Product Change Notification

PCN no	PCN2025020301	日期 Date	2025/2/3
客戶 Customer			
主旨 Subject	**ARAID M500 Casing & Tray Change**		
預估生效日期 Estimated Date of Change		2025/2/3

1. **ARAID M500 Casing: Material Change, Design Change, Process Change**

M500 Tray—Bottom View

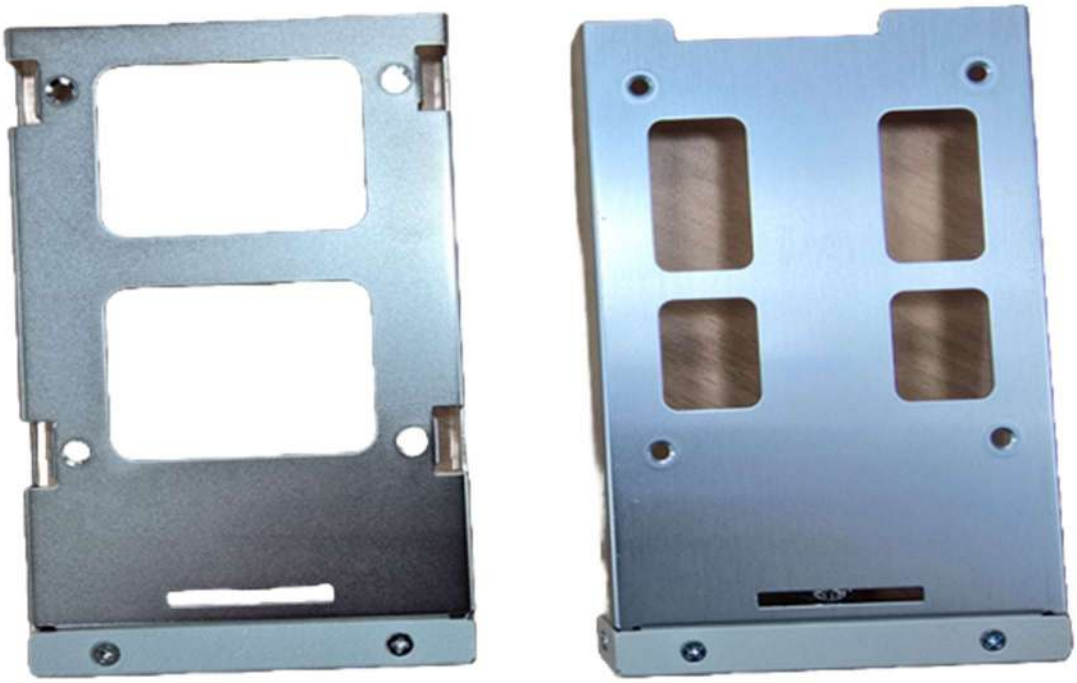
2. ARAID M500 Tray: Design Change

Before: Tray with Side Screw Holes

After: Remove Side Screws Holes, Add Opening for SATA Connector

Reason for Change:

- Make the tray easier to insert and remove
- Make the tray more robust
